FINAL ENVIRONMENTAL IMPACT REPORT

10131 Constellation Boulevard

ENV-2004-6269-EIR

April 2006

Figure 12
Existing Conditions and Proposed Project Shadows
Spring Equinox - March 21

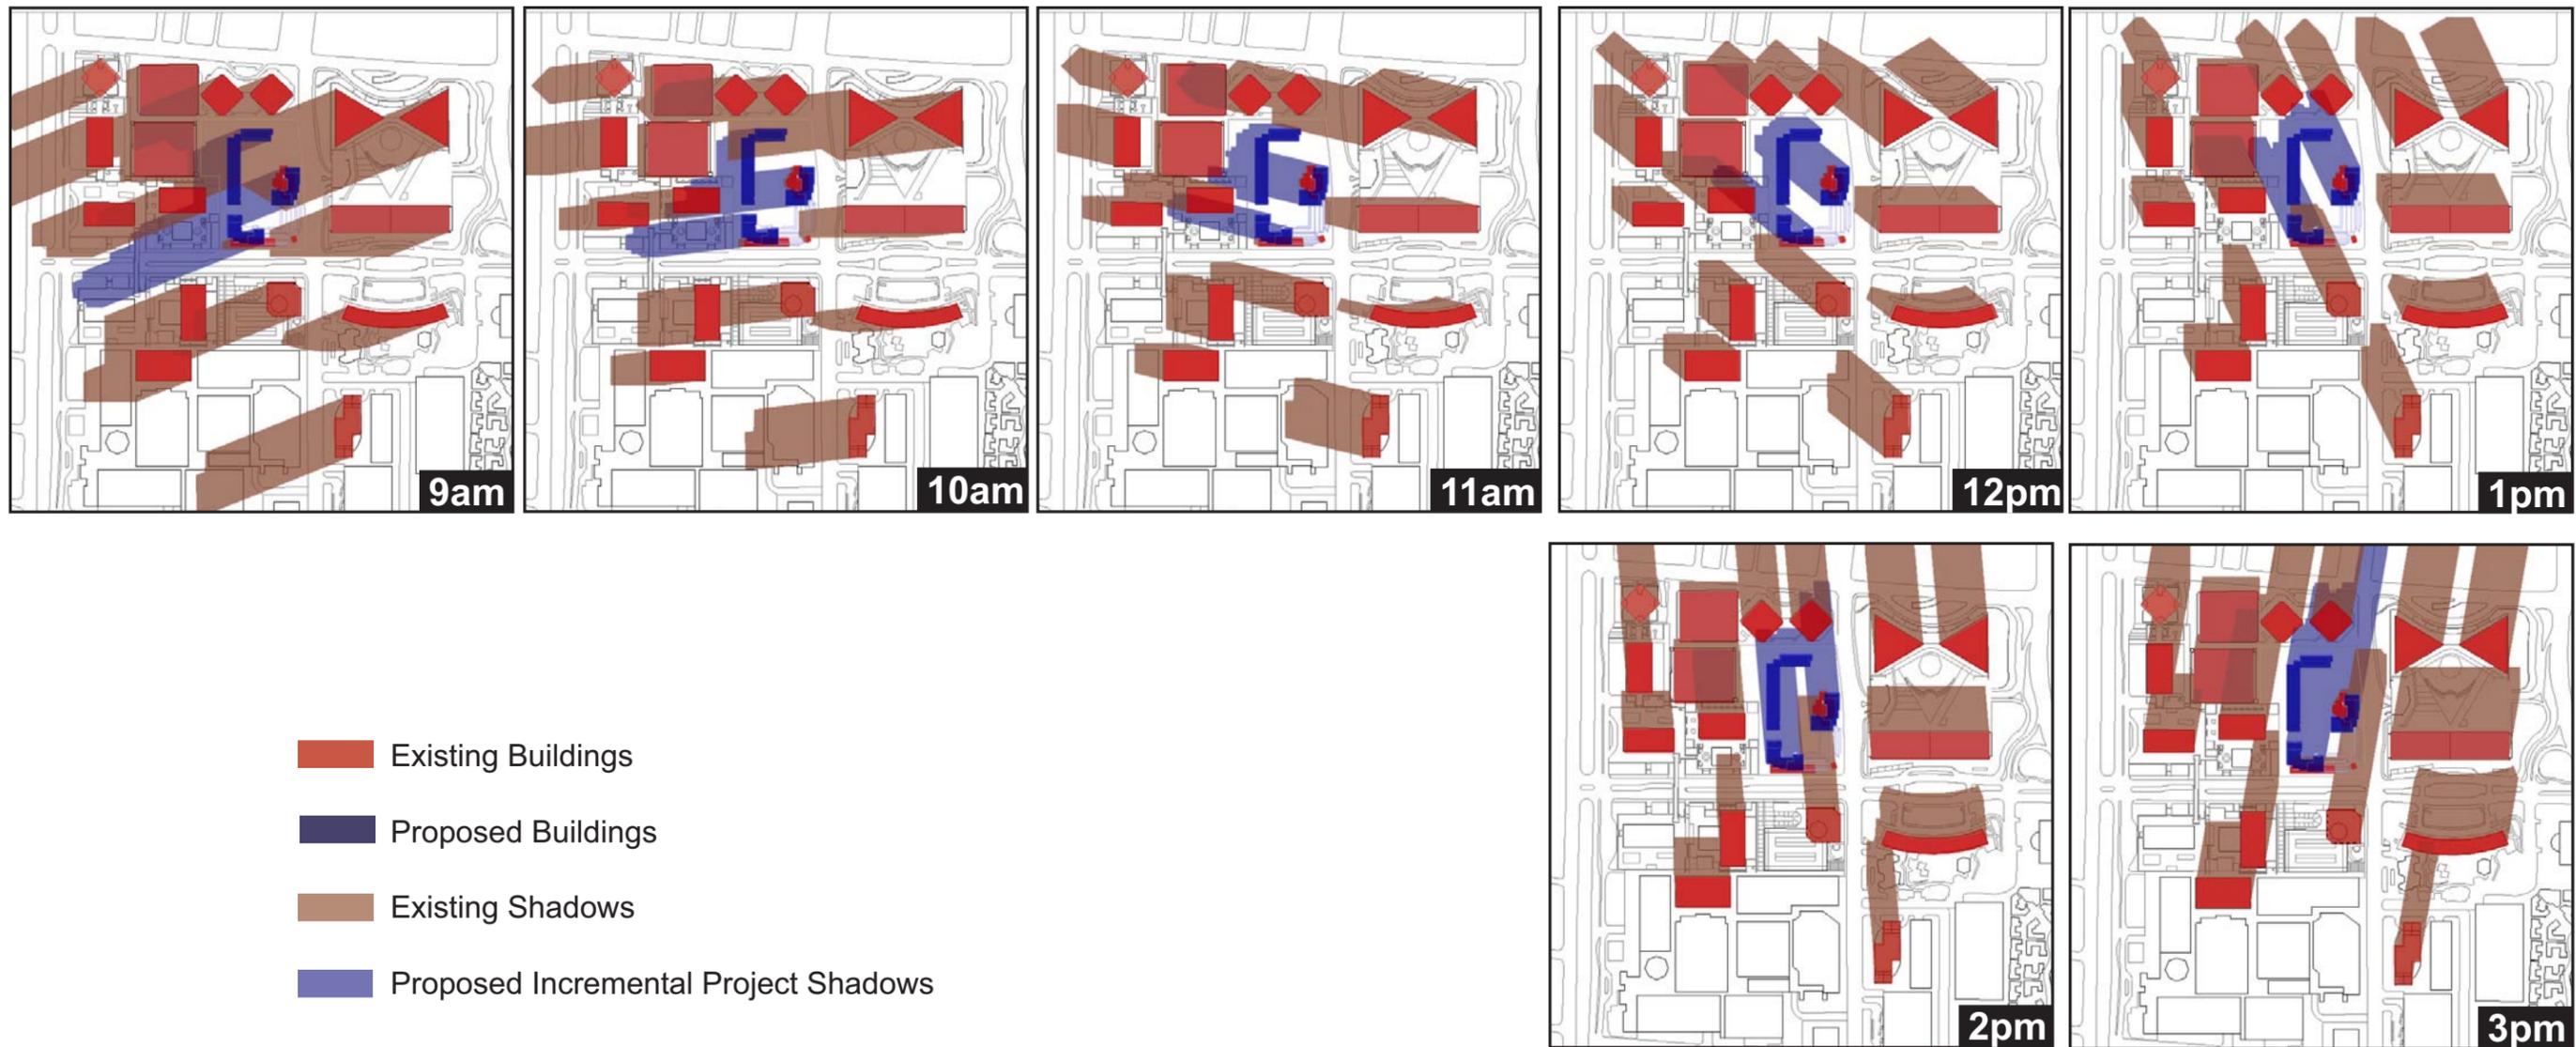
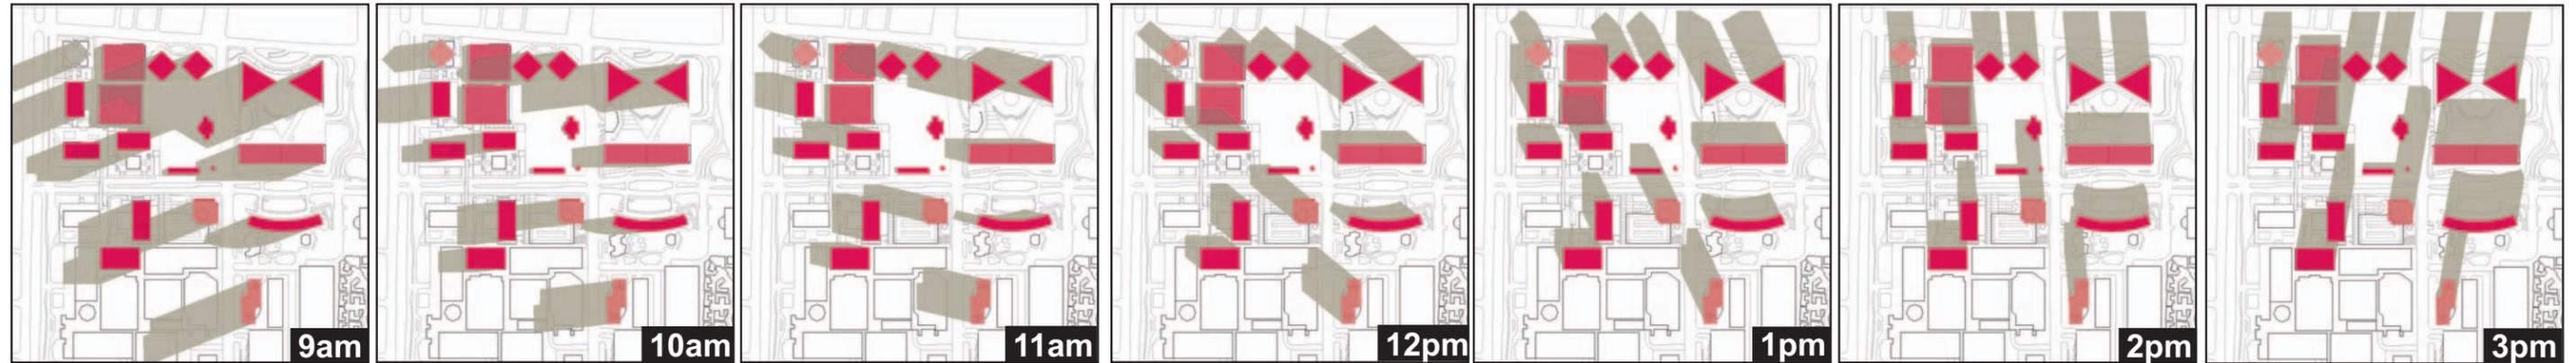
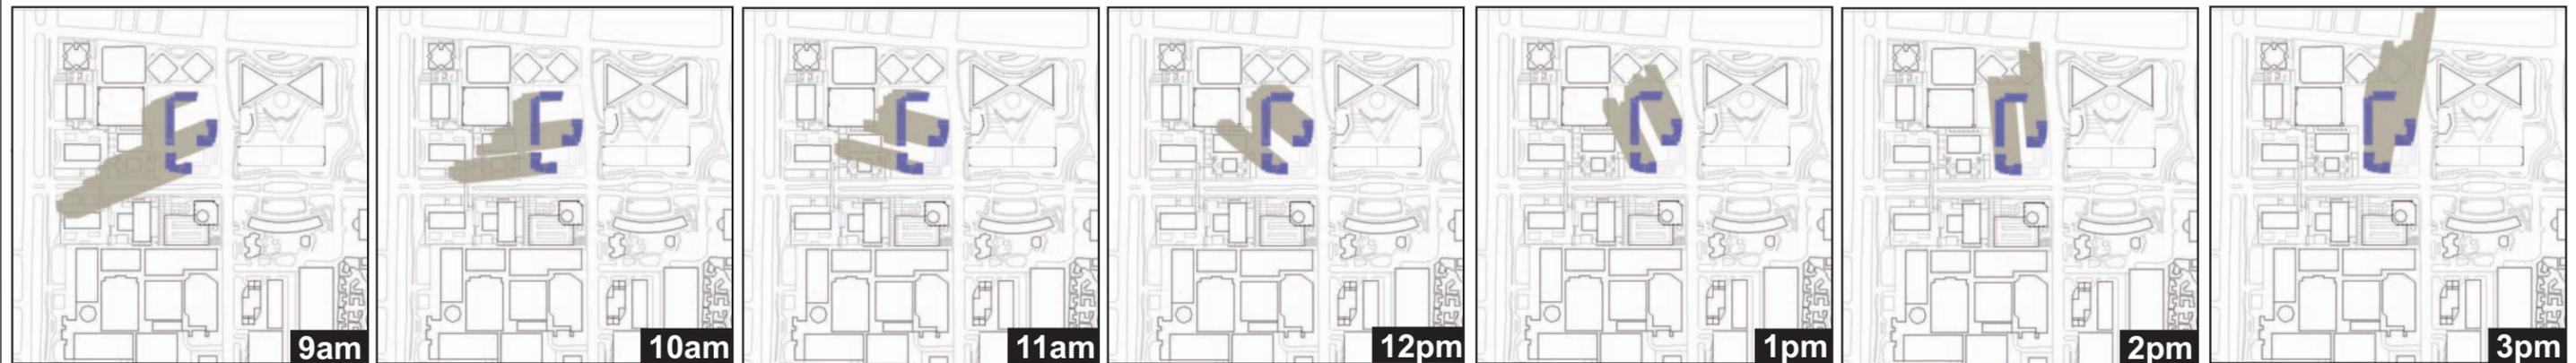
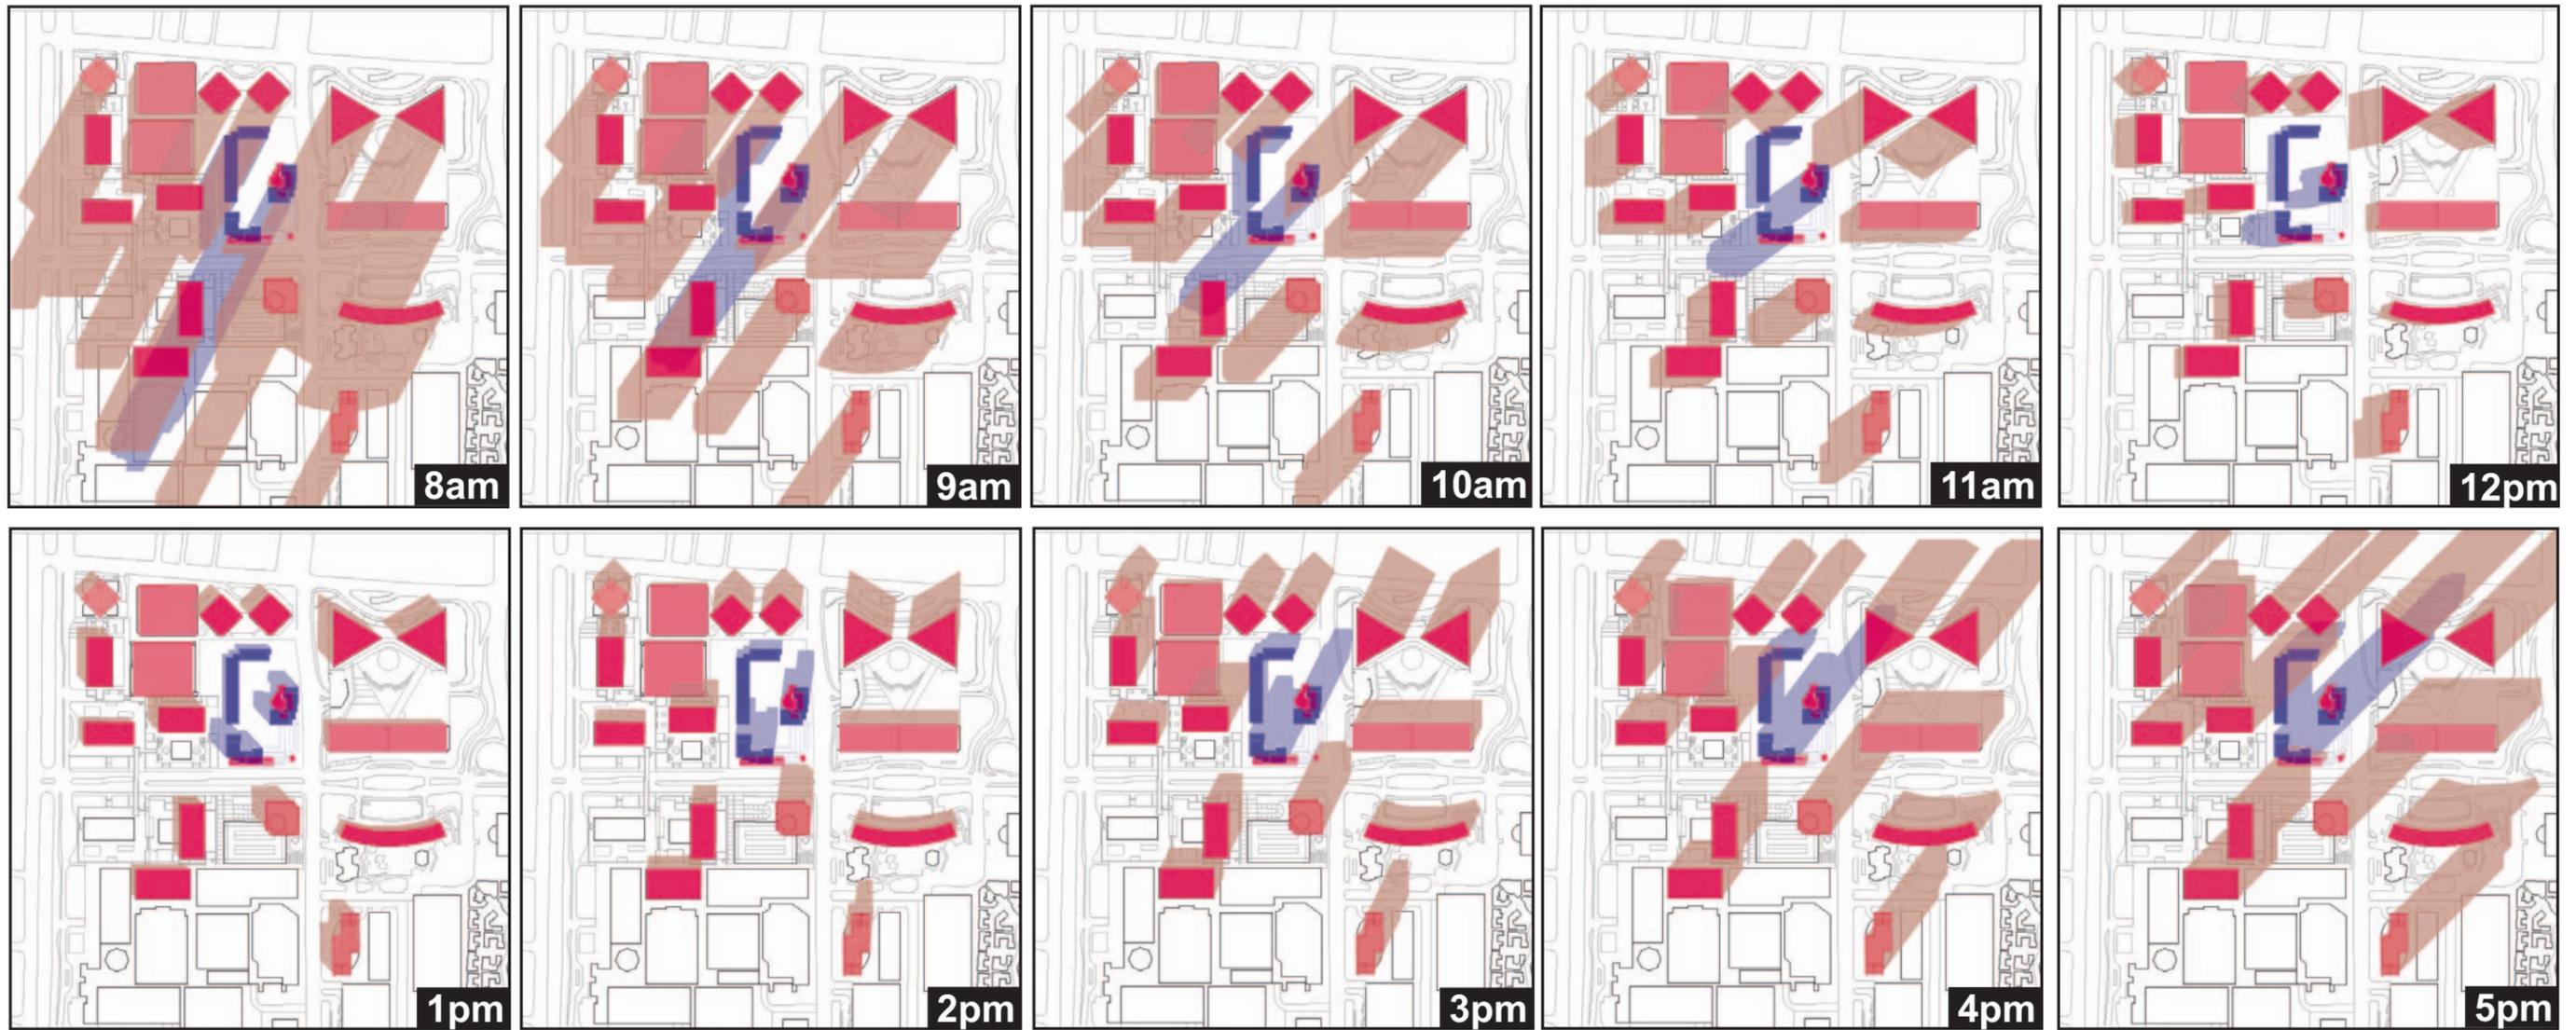
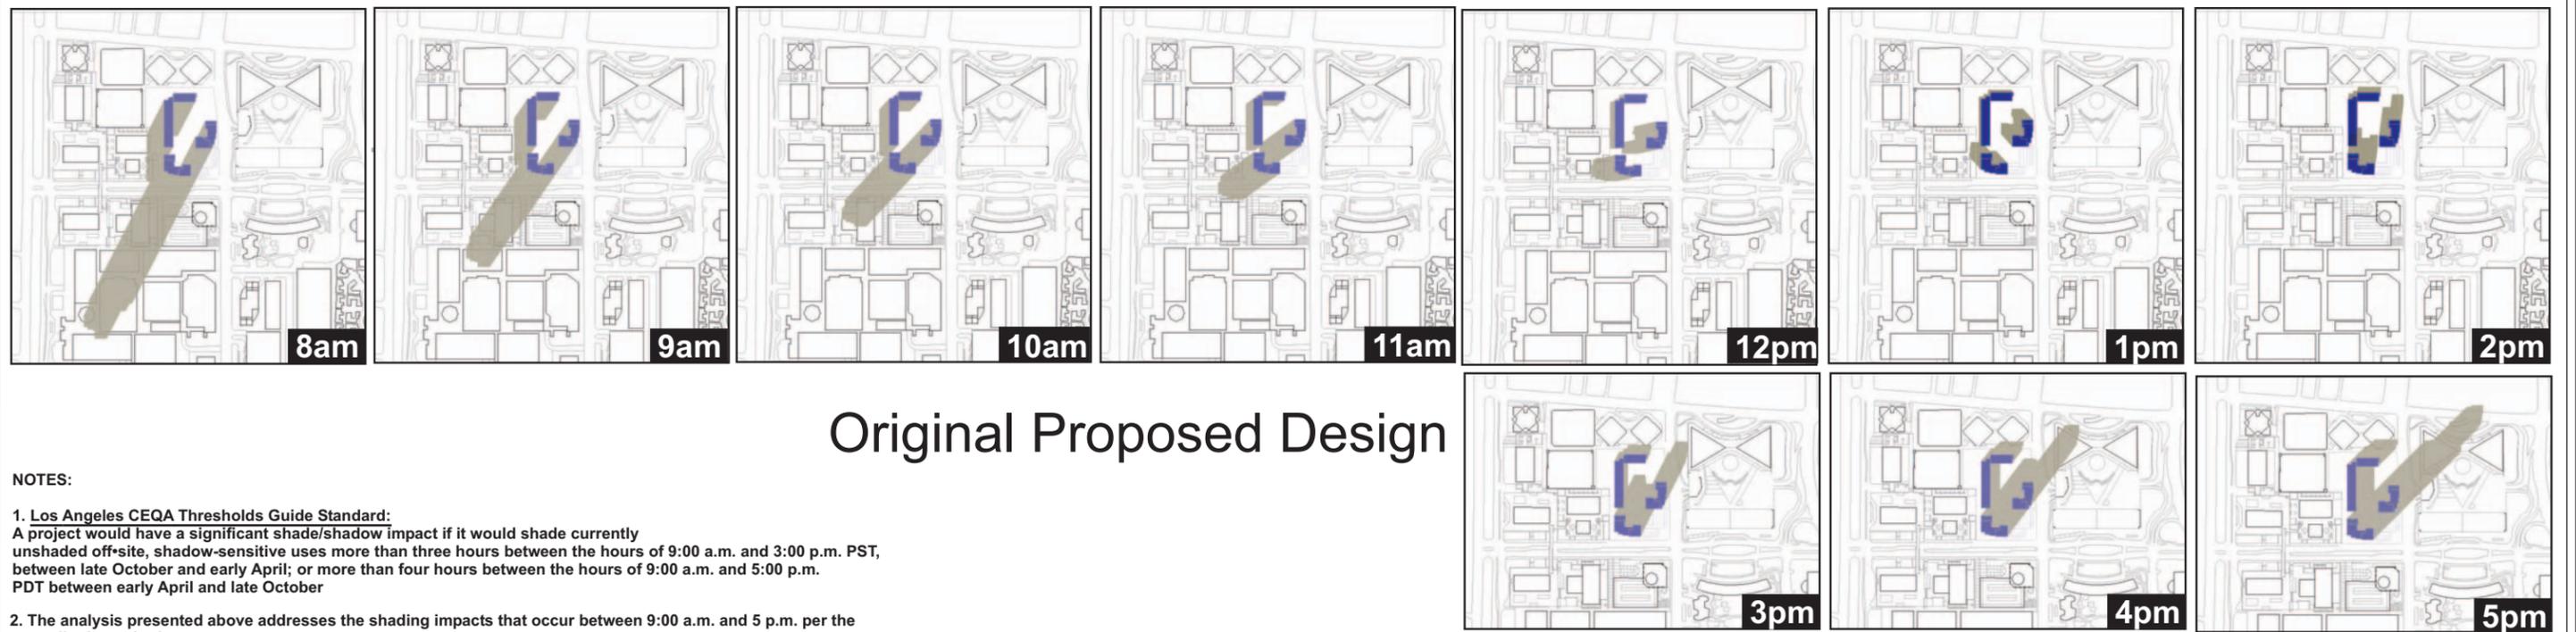
The exhibits depicting the Project's potential shade and shadow impacts under the various thresholds of significance depict multiple shadows at various times of the day in a single exhibit. As such, it is almost impossible to tell whether the thresholds are being exceeded due to the numerous overlapping shadows from various buildings during different time periods. The exhibits should be revised to depict a single time period.

The comment is noted and incorporated into the Final EIR for the review and consideration of the public and the City's decision makers prior to any approval action on the proposed Project. The shade/shadow simulations in Figures 45 through 52 of the Draft EIR clearly depict shadowing at specific hours of the day, corresponding to the times of day listed in the methodology for the shade/shadow analysis (Figures 45-52, Draft EIR, Section IV.C, page 252-261). The times of day shown in the figures are based on the intervals in which continuous shading would exceed threshold criteria. A single time period would not adequately show the potential for continuous shading according to the standards of the City CEQA Thresholds Guide and the CCNSP thresholds. The text of the shade/shadow analysis also explains what is occurring in the corresponding graphics. The revision of the shade/shadow graphics to show only a single time period would reduce the reader's understanding of the potential shade/shadow impact. Notwithstanding, the requested change in information is presented in Figure 10 through Figure 17 on pages 326 through 333 of this Final EIR.
